CITY OF MUSKEGON
PLANNING COMMISSION
REGULAR MEETING

STAFF REPORT

Hearing, Case 2019-02: Request for preliminary and final Planned Unit Development (PUD) approval for a residential development at 920, 1000, 1010, 1050 and 1060 W Western Ave.

Hearing, Case 2019-03: Request for several departures from the Form Based Code section of the zoning ordinance for the proposed residential development at 241 & 245 W Western Ave.

ILLUSTRATION 6.87 FRONTAGE COMPOSITION REQUIREMENTS

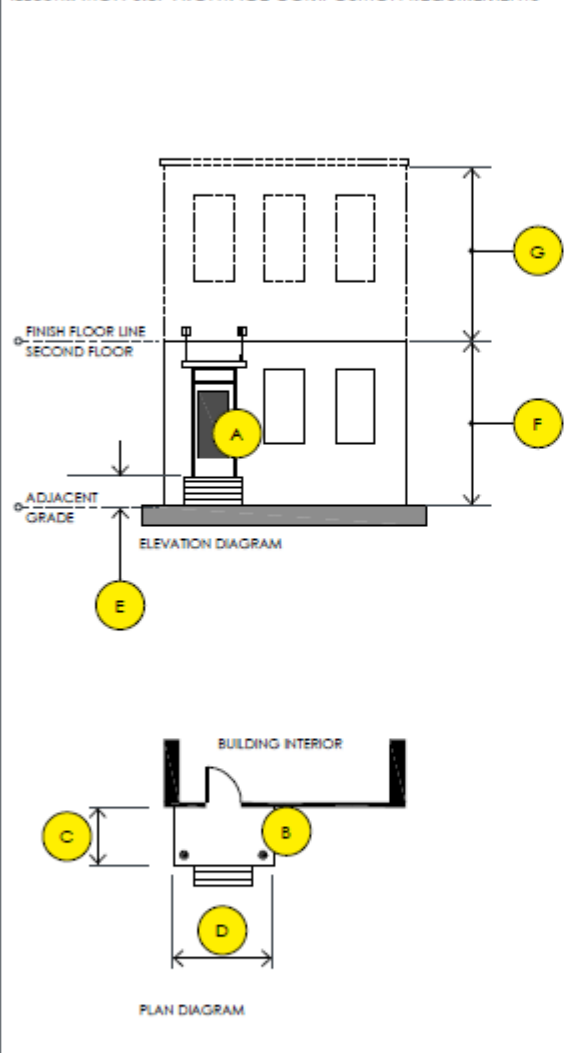
- The development does not meet all of the requirements of one the two choices for frontages, including “lightwell” or “stoop.” It meets all of the requirements of the stoop option, except the stoop will only be raised 5 inches off of grade, rather than the required 18 inches. Please see the regulations for these on the following pages.

- E. Stoop shall be 18" minimum above adjacent grade.
- F. Transparency: Stoop frontage shall have 10% to 50% of the façade be windows between the adjacent grade and the finish floor line of the second story. Entry door transparency shall be included as part of the required transparency calculation.
